Access Compliance Report

Public Rights-of-Way

Intersection ID: 17080	Main Street: MARYLAND_AV	Cross Street: WESTFIELD_RD	Location: NW
ADA ID: 1B3E48134183	Ramp Type: BlendTrans1	Initial Pass/Fail: Fail	Overall Compliance: No
		Severity Score: 12.5

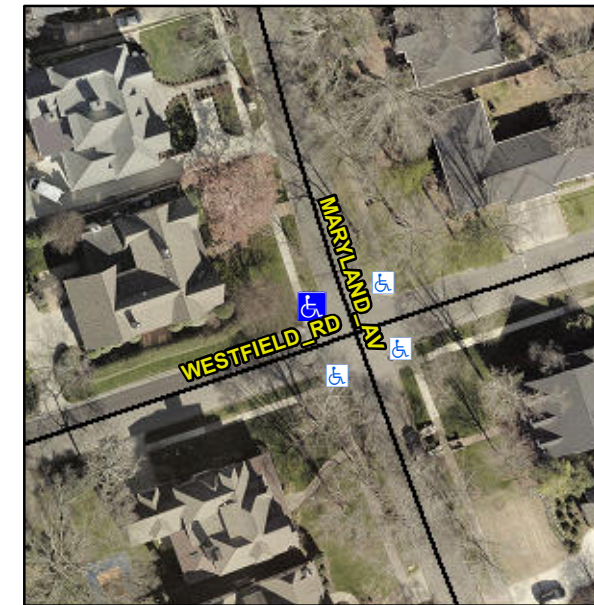
R304.5.3

Compliance	Description	Data	Compliance	Description	Data
N/A	Ramp Length (in)	88.0	Yes	BlendTrans Slope (%)	2.3
Yes	Ramp Width (in)	48.0	No	BlendTrans XSlope (%)	6.0
N/A	Flare Type LT	N/A	N/A	Flare Type RT	N/A
N/A	Flare Slope LT (%)	N/A	N/A	Flare Slope RT (%)	N/A
N/A	Flare Traversable LT?	N/A	N/A	Flare Traversable RT?	N/A
N/A	Landing Length (in)	N/A	N/A	DWS Provided?	N/A
N/A	Landing Width (in)	N/A	N/A	DWS Contrast?	N/A
N/A	Landing Slope (%)	N/A	N/A	DWS Length (in)	N/A
N/A	Landing X Slope (%)	N/A	N/A	DWS Full Width?	N/A
N/A	Landing Curb? (Y/N)	N/A	N/A	DWS Offset (in)	N/A
N/A	Shared Landing?	N/A			
N/A	Gutter Ponding?	N/A	N/A	Gutter Slope (%)	N/A
N/A	Gutter Lip Ht (in)	N/A	N/A	Gutter X Slope (%)	N/A
N/A	Painted X Walk1?	No	N/A	Painted X Walk2?	No
	X Walk 1 Direction	To SE		X Walk 2 Direction	To NE
	X Walk 1 Width (in)	N/A		X Walk 2 Width (in)	N/A
	X Walk 1 Slope (%)	6.1		X Walk 2 Slope (%)	3.9
	X Walk 1 X Slope (%)	2.3		X Walk 2 X Slope (%)	4.7

Remove & Replace Curb Ramp With Two New Directional Ramps or Equivalent.
